TOWN OF PLAINFIELD PLAN COMMISSION REPORT

DATE: 05-05-2025 [*Revised from 4/10 report*]

PROJECT: [Crew Interior Clean](#)

REQUESTED ACTIONS: [RZ-25-005](#) Rezone of approximately 2.51 acres from GC: General Commercial and R-3 Medium Density Residential to AC: Automotive Commercial
[PP-25-005](#) Primary Plat approval for a one-lot commercial subdivision
[DP-25-005](#) Architectural and Site Design Review for a proposed Crew Interior Clean facility

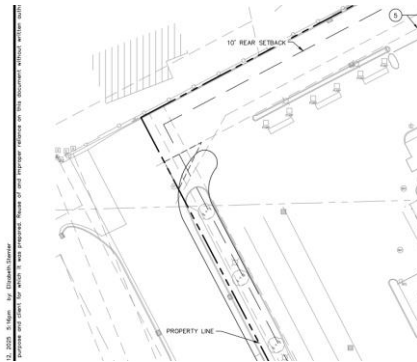
2. *[Added from 4/10 report: Access to the site has been modified (sometime between 2018 and 2020) since the property was originally developed in 2001. Staff have been unable to locate documentation indicating that the curb modification was approved by the Town. Initially the petitioner stated that the original design would be restored as a part of this project, and the plans submitted and reviewed by staff and the Design Review Committee (DRC) reflected this intent. Upon release of the original staff report for the April 10th public hearing, the petitioner conveyed to staff that the existing access and curb design would remain unchanged, citing concerns with ongoing maintenance and repair associated with vehicles damaging the previous configuration. While the petitioner’s concerns are valid, other options such as a mountable curb could decrease the likelihood of damage while providing a more defined point of access.*

The petitioner has provided a set of draft commitments which propose potential future access reconfiguration upon certain conditions being present. The commitments are addressed in further within the Transportation comments.

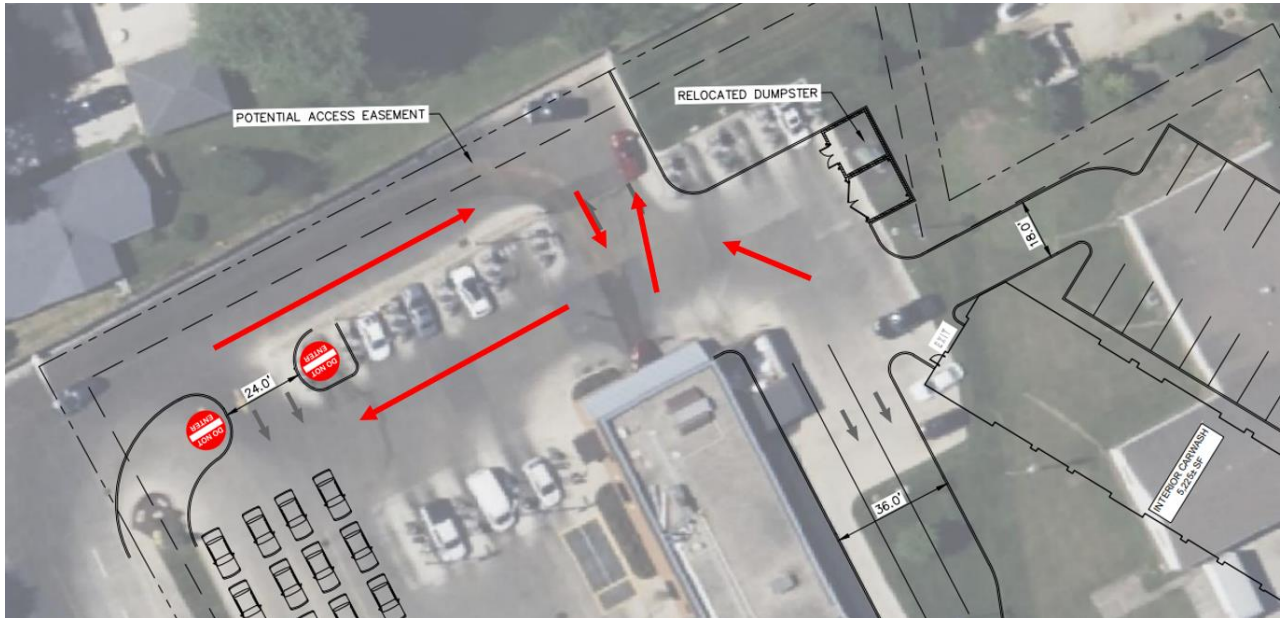
1. Williams Trace, currently a Private Street, is expected to get extended north in the future to connect to Station Boulevard. At that time, the Town would request that Williams Trace become a Public Street.
2. Due to its overall popularity, subscription model, and seasonal uses, this Crew Car Wash can be significantly overwhelmed with customers to the point where queuing far exceeds the available space on site, can consume the entire entry lanes of Williams Trace, and can even create some backups at Main Street.
3. The site has not historically allowed for cross-parcel access to the east. Cross-parcel access is expected to have increased benefits for drivers as traffic volumes continue to grow on Main St.

1. Currently, Williams Trace is owned by Premier Ventures, LLC. And though Crew Car Wash, amongst others, has rights to access their property through the street, Staff has advised the Petitioner that the Town would prefer for Crew to take ownership of the street given its key reliance for access and operations. Crew has indicated it is taking steps to obtain ownership of the street parcel(s). *[Note: Beacon incorrectly labels a piece of Williams Trace as being owned by the Town]*

2. To start, Crew does not allow for an interior service without an exterior wash. This helps to ensure a predictable queuing alignment onto and through the site (eliminates a drive to Main St.), but more importantly, limits the expectation this site will receive significantly new traffic because of the proposed added service. Secondly, Crew has agreed to make a pair of changes that will help position the site to operate with reduced impacts to Main St., both now and in the future when Williams Trace extends:

- i. Crew has agreed to implement what it is referring to as a Safety Plan, which effectively expands the onsite queuing to encumber space reserved for vacuums while also deploying a pair of signs at Williams Trace and Main St. to tell customers to "Return in 15 Minutes".

- ii. Perhaps more importantly, Crew is agreeable to a future accommodation to shift their entrance to their eastern drive in order to create added queuing on their Interior Access Drive and in their own site area. This is expected to be a needed change once Williams Trace converts to a Public Street. *[Added from 4/10 report: And while the Petitioner is willing to commit to these changes, it has requested that these potential, future changes be deferred until some time in the future once Williams Trace gets extended and becomes public and a better determination of the public safety impacts under those conditions can be determined. The Petitioner has submitted a document titled 'Commitments Concerning Use and Development of Real Estate' that is intended to address these concerns and future accommodations. For the Plan Commission's consideration, Staff has included a proposed condition under the Motion for RZ-25-005 that would make this document a legal obligation by the Petitioner for the future when the identified conditions are satisfied.]*
